STATE OF NORTH CAROLINA  
DEPARTMENT OF TRANSPORTATION

April 27, 2010

SUBJECT: Lee County, US 421-NC 87 Sanford Bypass from existing US 421 northwest of Sanford to existing NC 87 southeast of Sanford (R-2417C) and from west of SR 1400 to west of US 1-15-501 (R-2417AA); T.I.P. Number R-2417C and R-2417AA; Federal-Aid Project STPNHF-421(2); WBS No. 34431.1.1

Attached are the modifications to the U.S. Army Corps of Engineers Section 404 Individual Permit 404 and N.C. Division of Water Quality Section 401 Individual Water Quality Certification for the above referenced project. All environmental permits have been received for the construction of this project.

**PRELIMINARY PLANS**  
 DO NOT USE FOR CONSTRUCTION  
**Permit Drawing**  
 Sheet 14 of 41

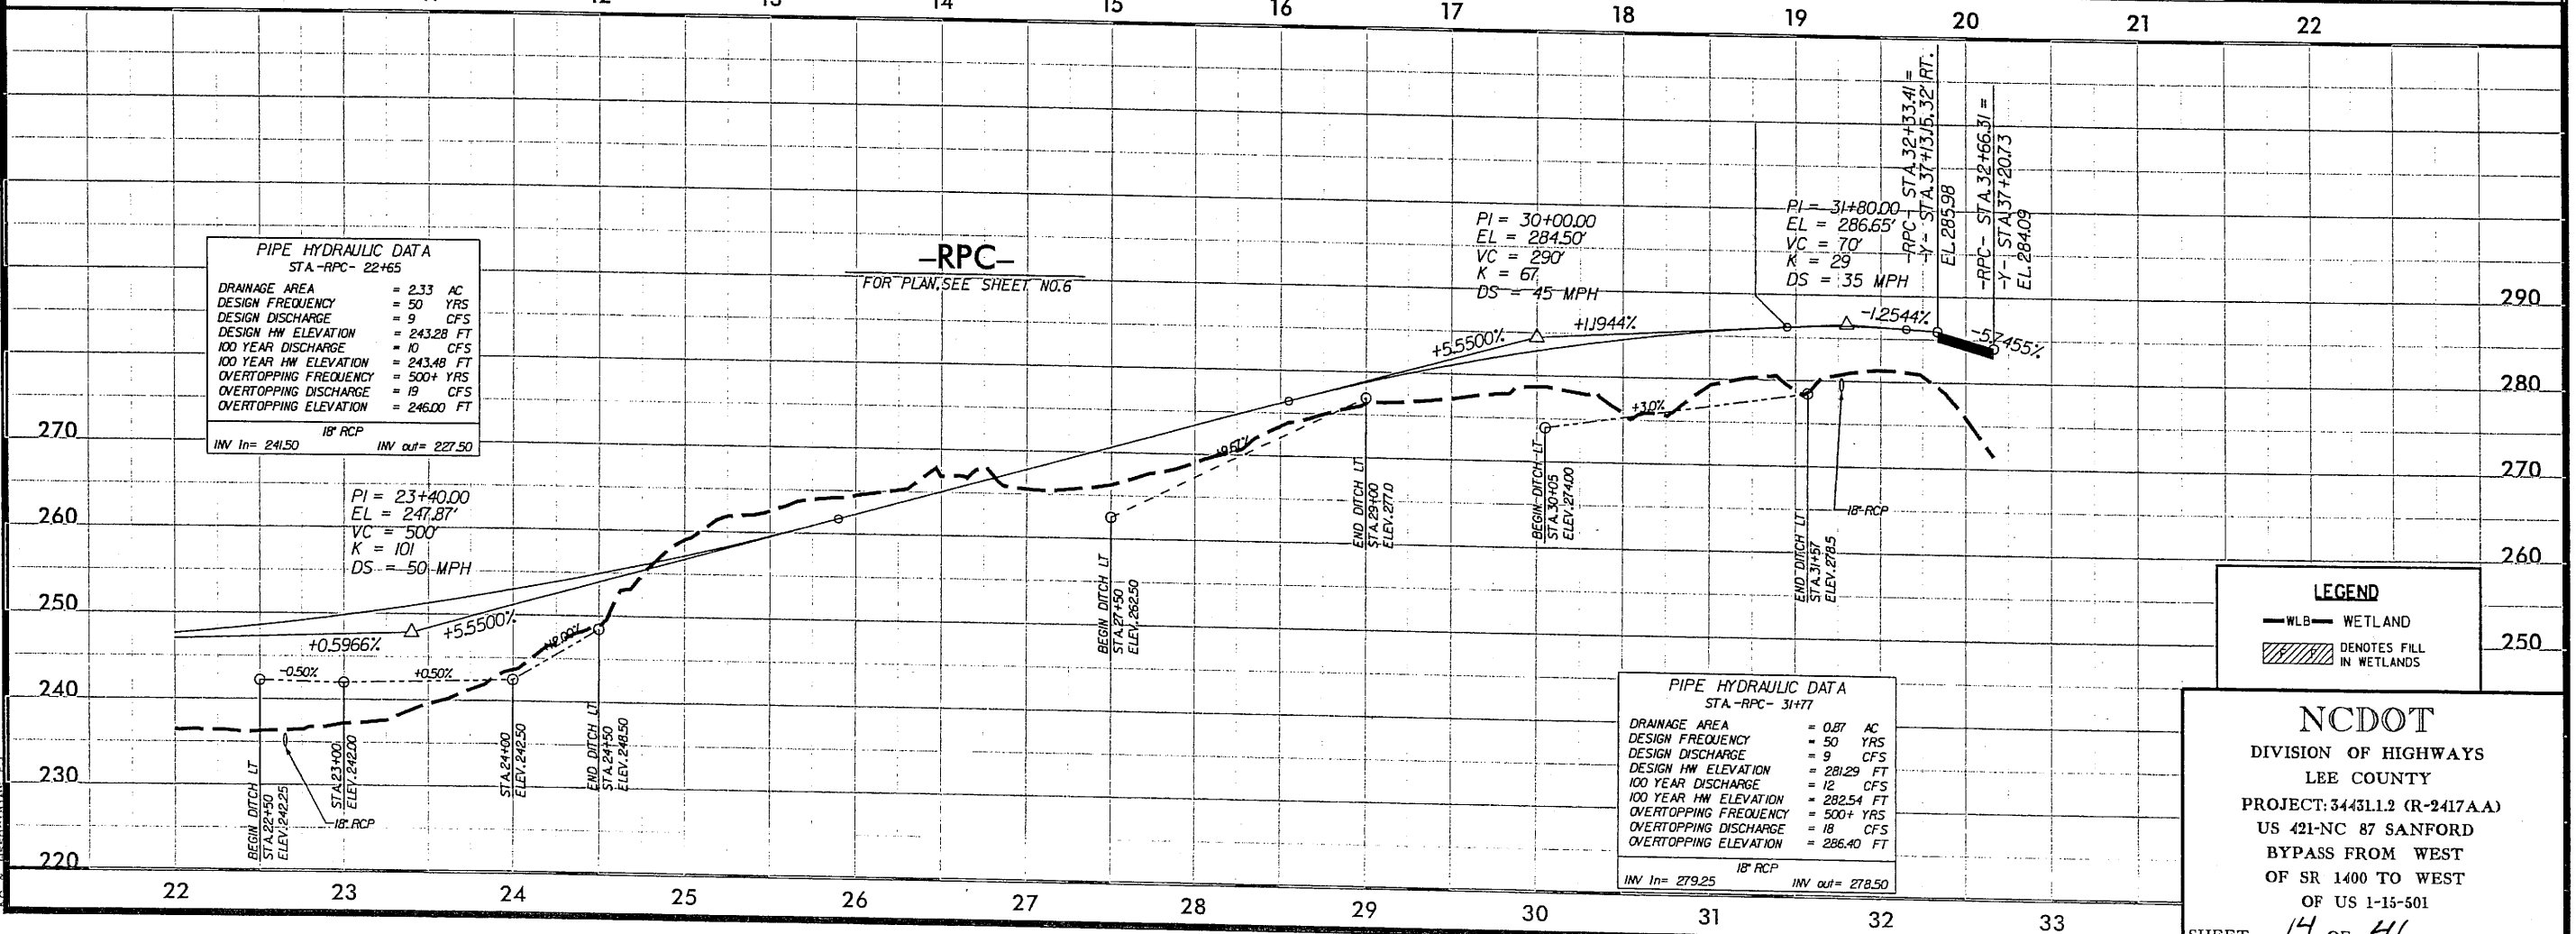
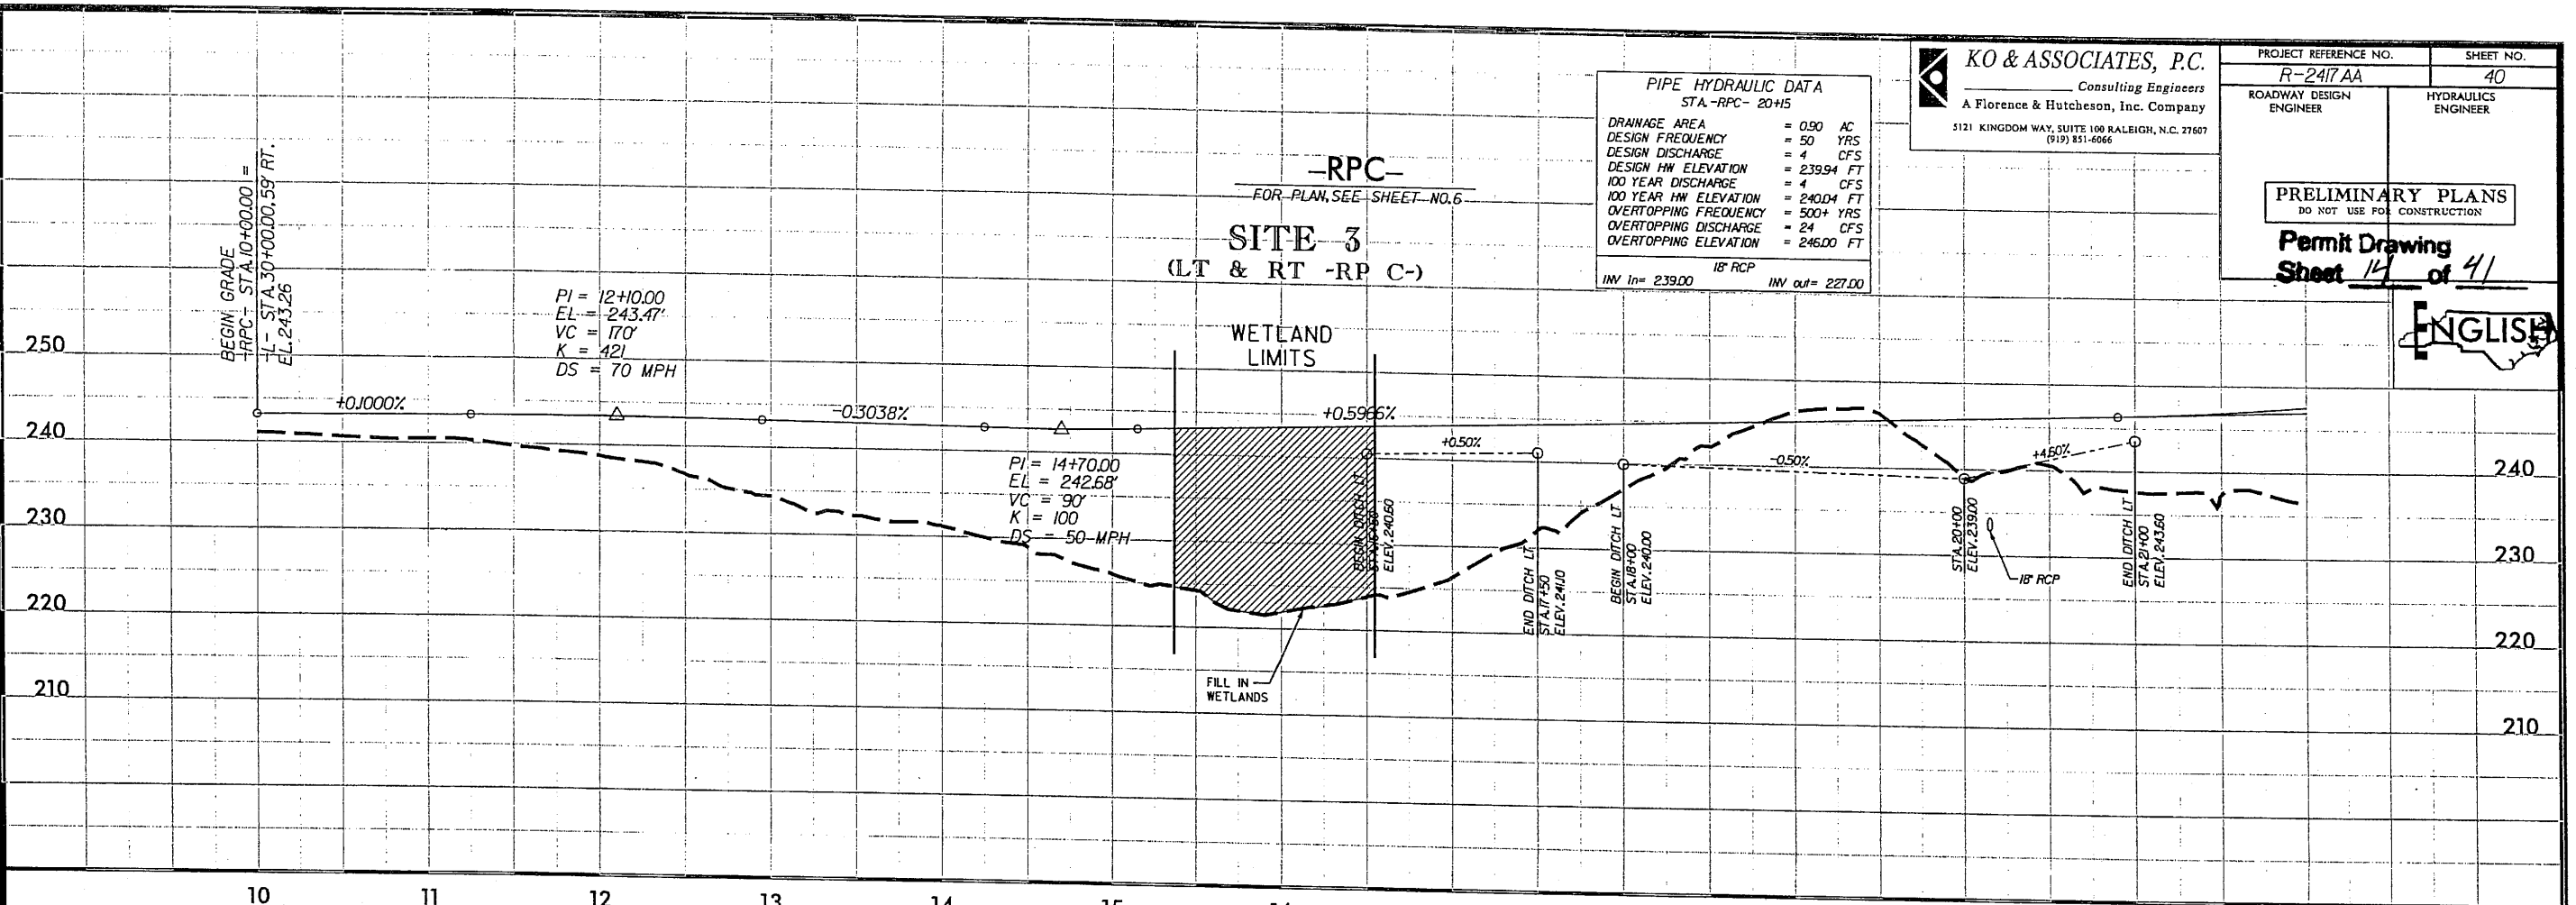
1. The natural rock energy dissipator proposed at Permit Site #16 (Permit Drawing Sheet 14 of 31) shall be constructed per Detail Sheet 2-K. Rock used to construct the dissipator and associated "rock sill" shall be constructed so that low flow passage of water or aquatic life is impeded.

Permit Drawing  
 Sheet 16 of 41

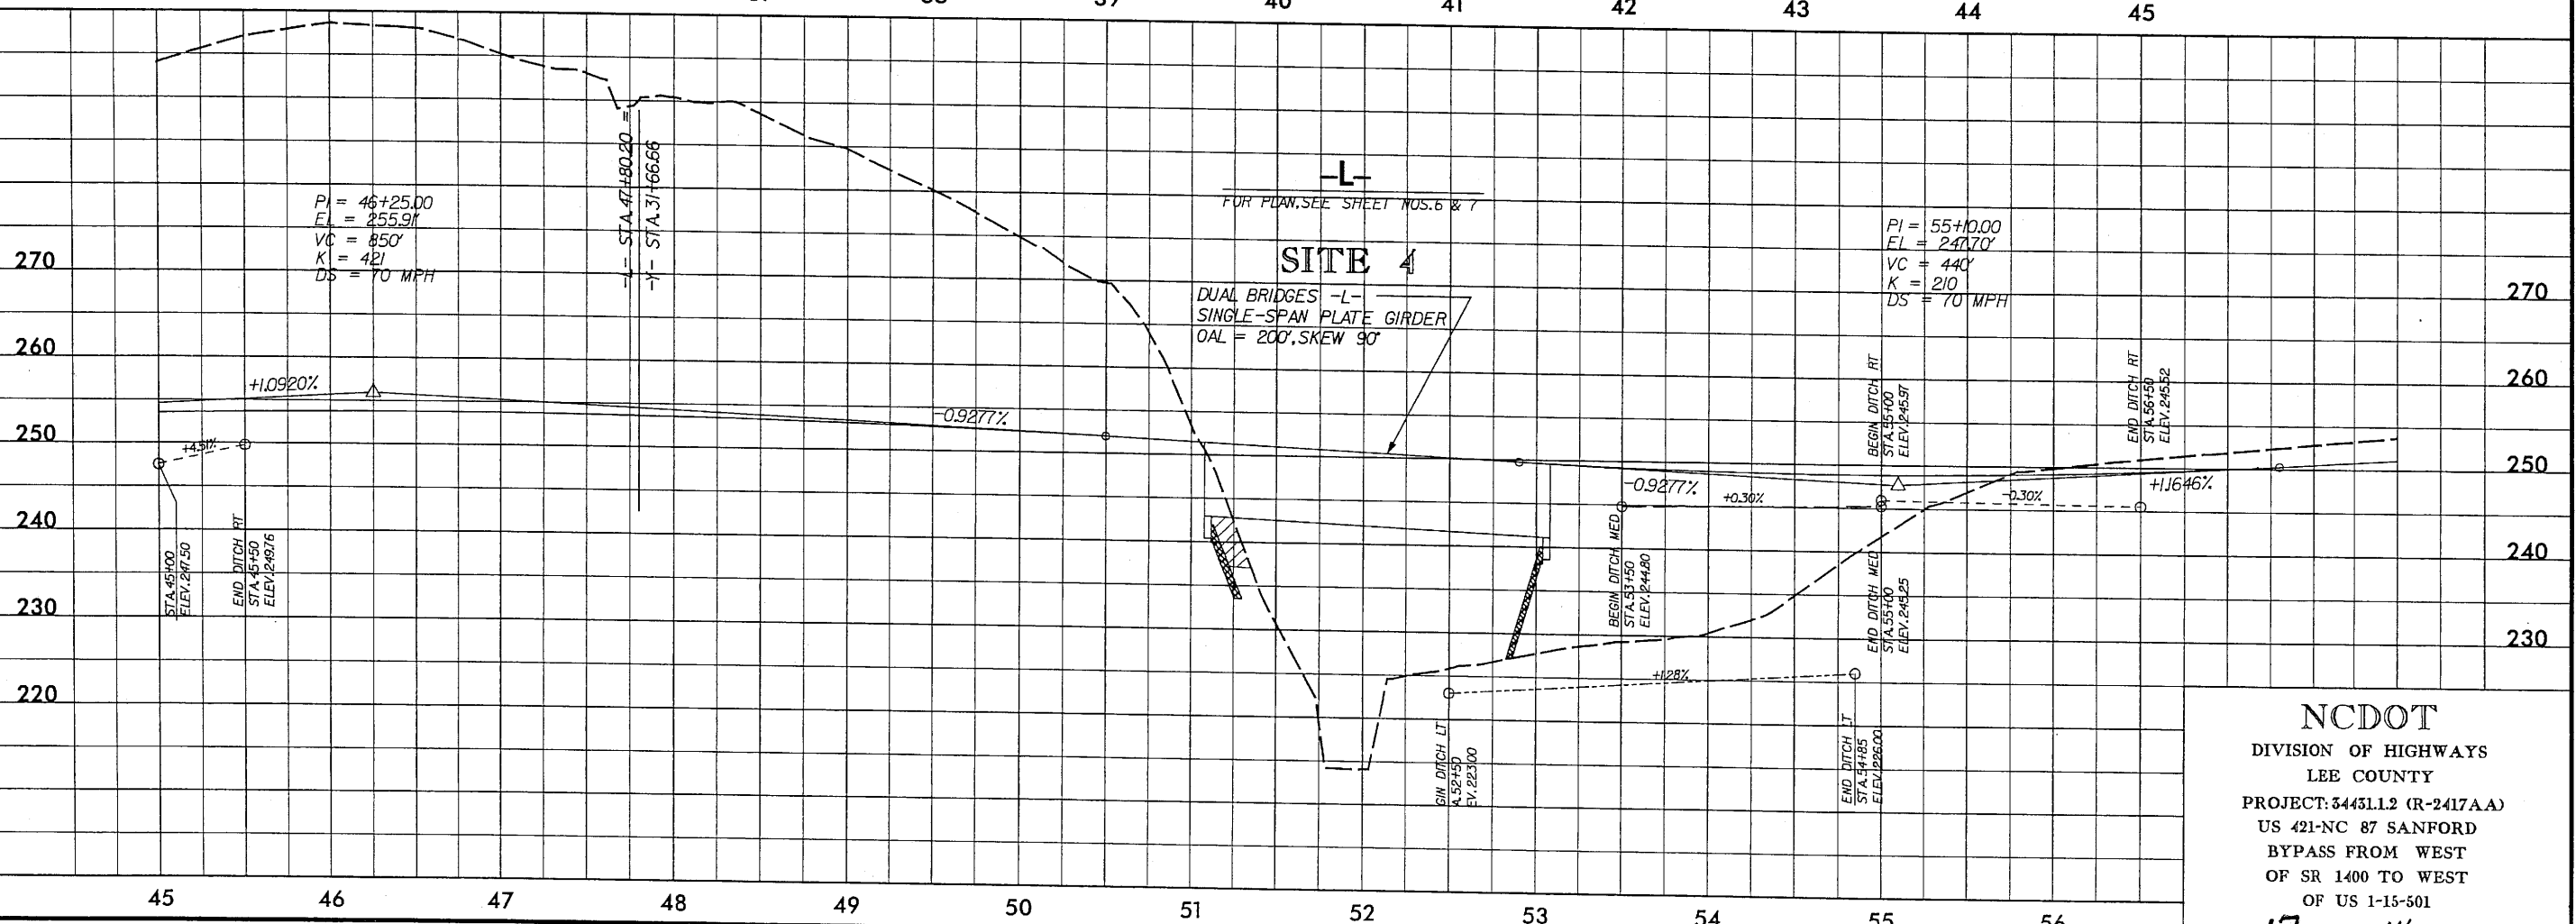
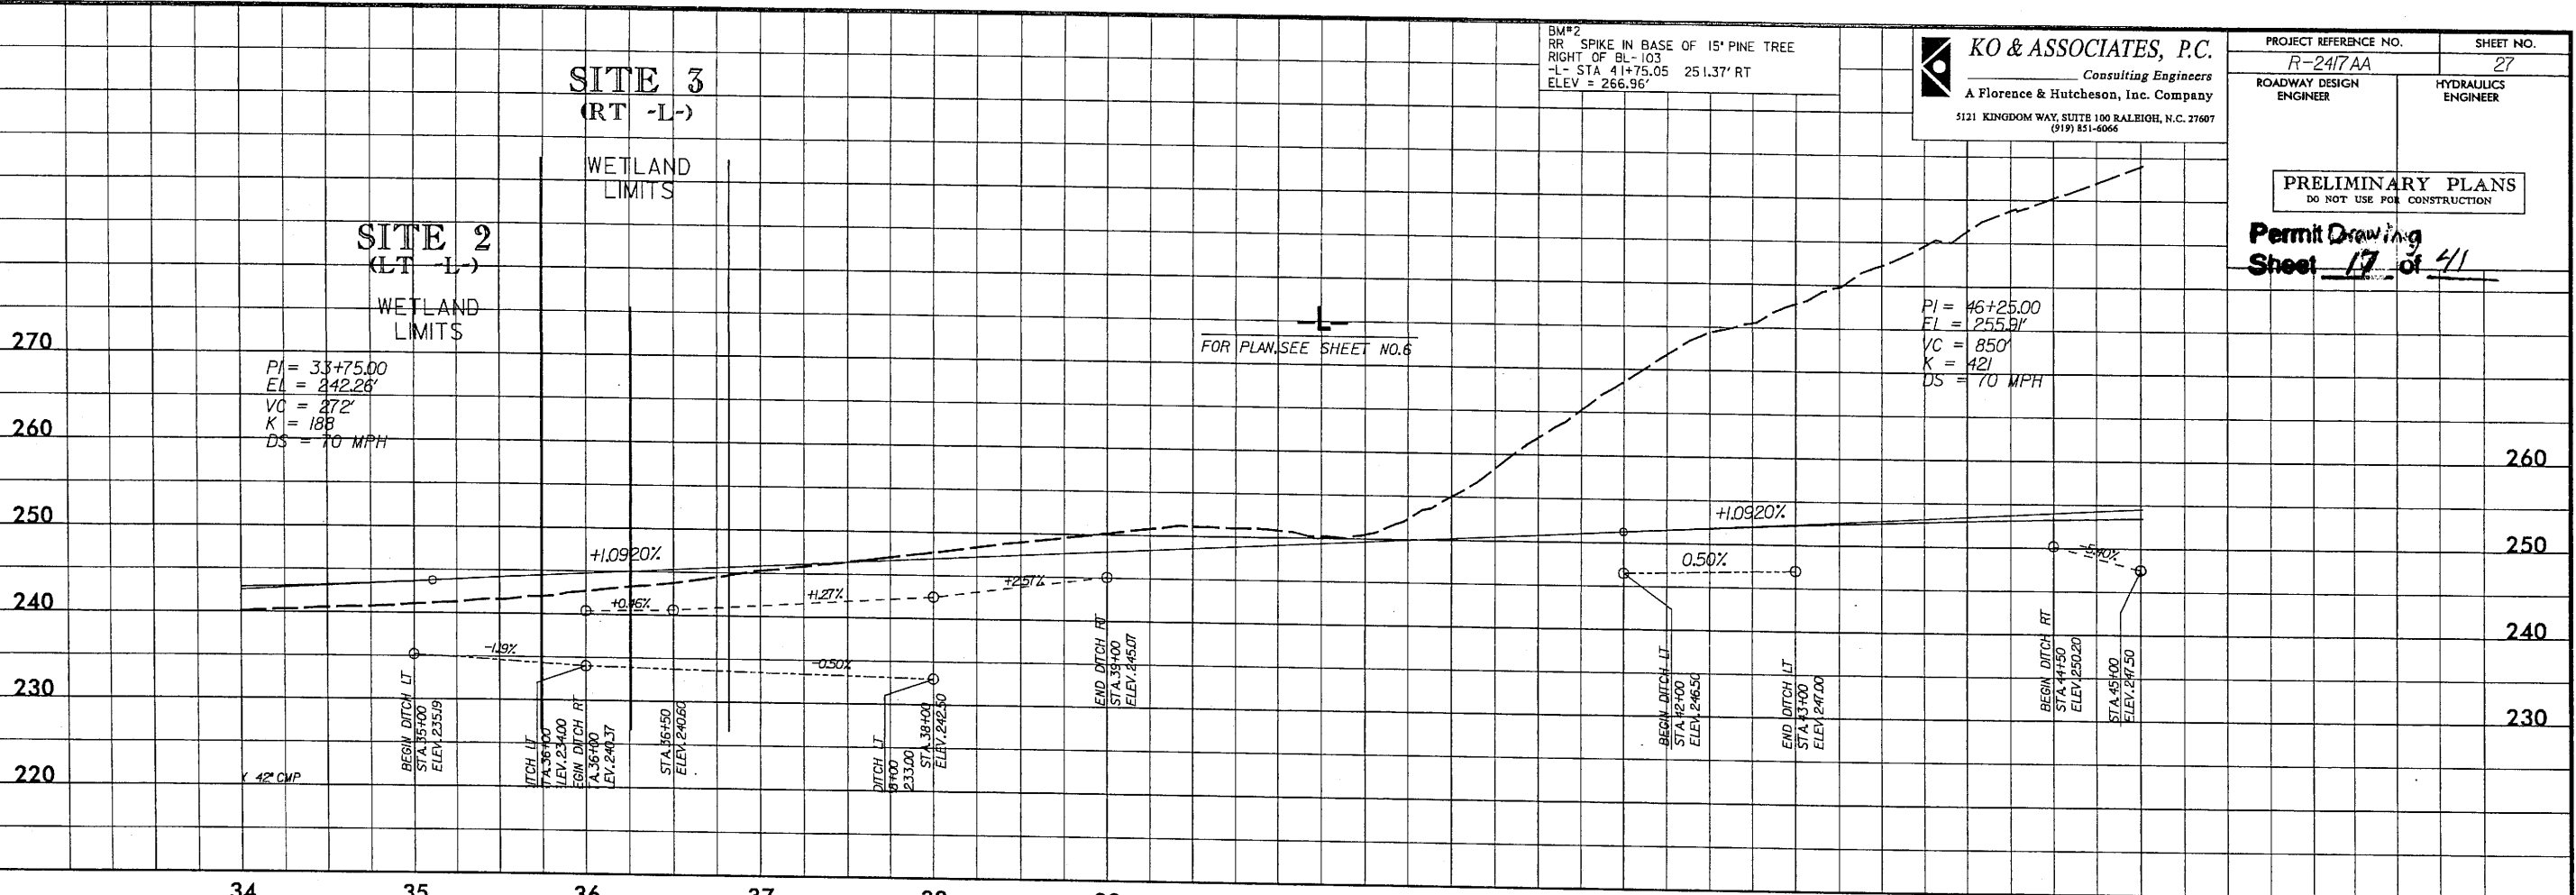
2. A natural rock energy dissipator (Detail Sheet 2-K) is proposed on the stream bank, in a level area for constructability (per NCDOT staff) at Permit Site #2 (Permit Drawing Sheet 16 of 31, -YRPC-). The dissipator is designed such that storm flows will be directed upstream once they exit the dissipator. NCDOT is advised that if the stream destabilizes in this area due to backwater or other conditions caused by the dissipator alignment, corrective actions to stabilize the stream will be required.

3. Two (2) ditch lines are proposed on the stream banks at Permit Site #2 (Permit Drawing 16 of 31, -YRPC-) which discharge into the stream at nearly right angles. NCDOT is advised that if stream bank destabilization occurs as a result of the ditch line alignments, corrective actions to stabilize the stream will be required.

1. A sill shall be placed on one of the box culverts to maintain the natural stream dimension at Permit Sites 2 (Permit Drawing 16 of 31) and 7 (Permit Drawing 30 of 31).
